Project	<b>IEEE 802.16 Broadband Wireless Access Working Group</b> < <a href="http://ieee802.org/16">http://ieee802.org/16</a> >	
Title	<b>A Key Management Method for the Multicast Service</b>	
Data Submitted	<b>2004-03-09</b>	
Source(s)	Seokheon Cho Ae Soon Park Chulsik Yoon SungCheol Chang Kyung Soo Kim	Voice: +82-42-860-5524 Fax: +82-42-861-1966 <a href="mailto:chosh@etri.re.kr">chosh@etri.re.kr</a> <a href="mailto:aspark@etri.re.kr">aspark@etri.re.kr</a>
	ETRI 161, Gajeong-dong, Yuseong-Gu, Daejeon, 305-350, Korea	
Re:	This is a response to a Ballot #14 Announcement IEEE 802.16-04/06 on IEEE P802.16e-D1.	
Abstract	The document contains suggestions on the changes in IEEE P802.16e-D1 that would support to negotiate authorization policy between the existing device authentication and the user authentication.	
Purpose	The document is submitted for review by Handoff/Sleep-mode Ad Hoc Group and/or by 802.16 Working Group members

## A Key Management Method for the Multicast Service

Figure 127 - TEK state machine flow diagram

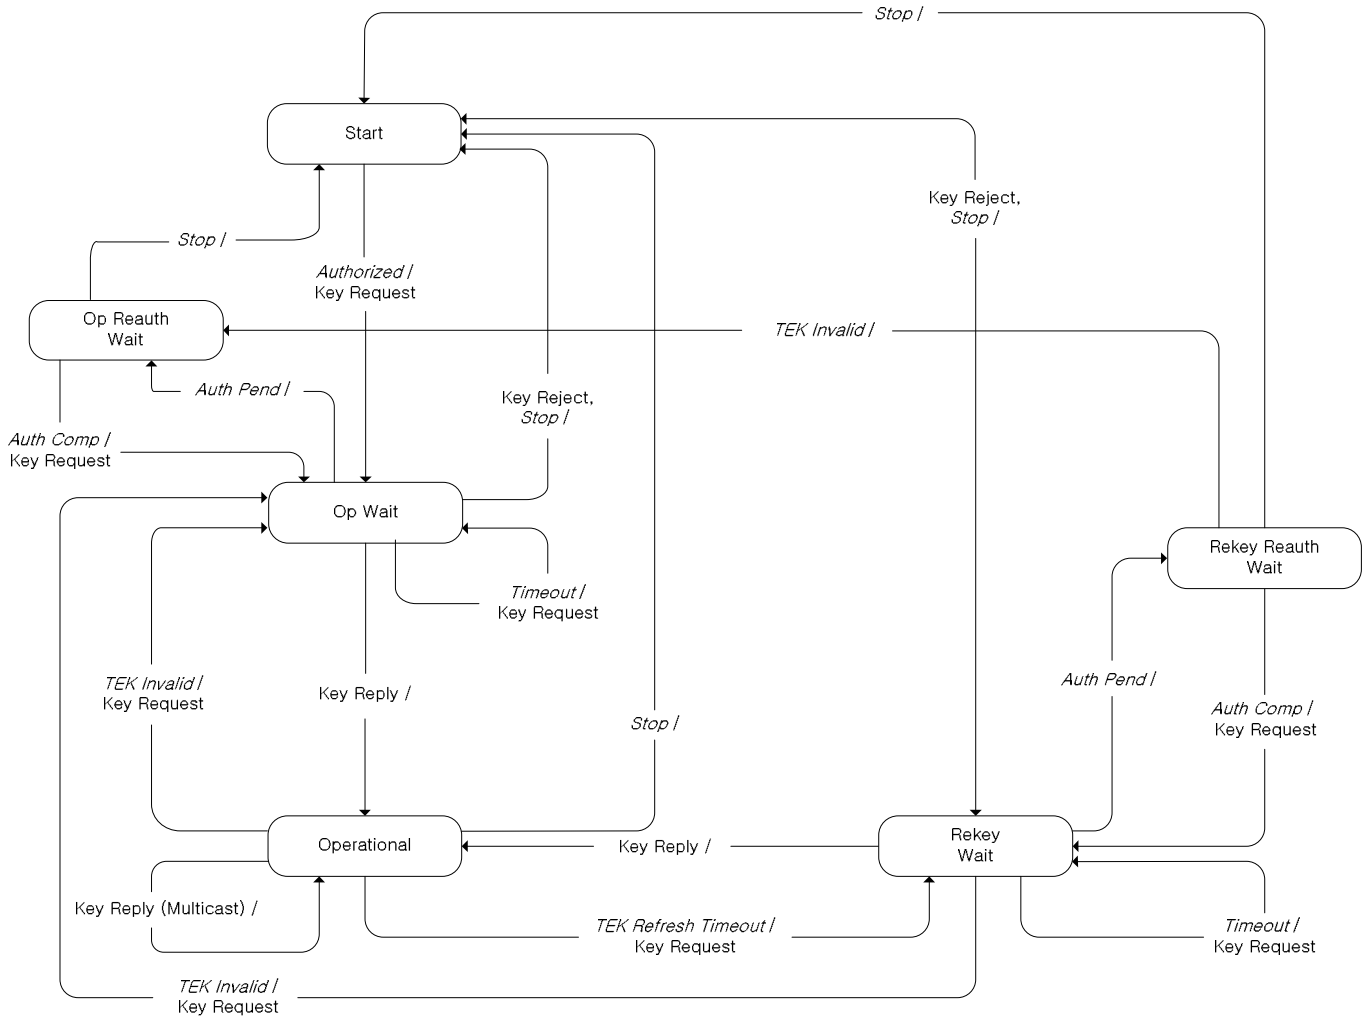
[Change the Figure 127]

NOTE: The state, Operational (D), can be transited to the “Operational” state by receiving the Key Reply message for the multicast transport service such as “8-D”.
